Control Power Board fixes

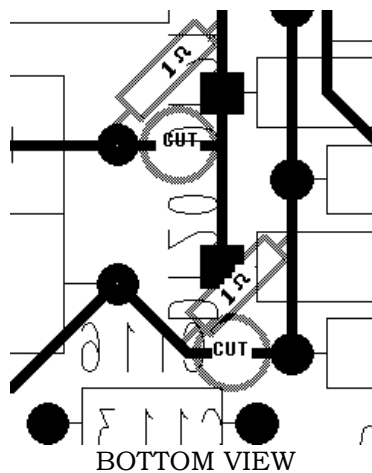
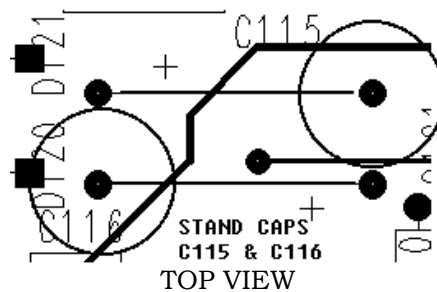
- Replace C115, C116 with 65uF 63V capacitor. Stand these caps on there **NEGATIVE** lead.
- Replace C125, C127 with 36V zener, 1N5365B (or 12V&24V in series 1N4742, 1N4749)
- Cut trace on bottom of PCB between D103 anode and neg lead of C116 as shown in sketch, and add a 1 ohm 1/2W resistor. Cut trace on bottom of PCB between D120, D121 cathodes and pos lead of C115 as shown in sketch, and add a 1 ohm 1/2W resistor. (R121, R122)
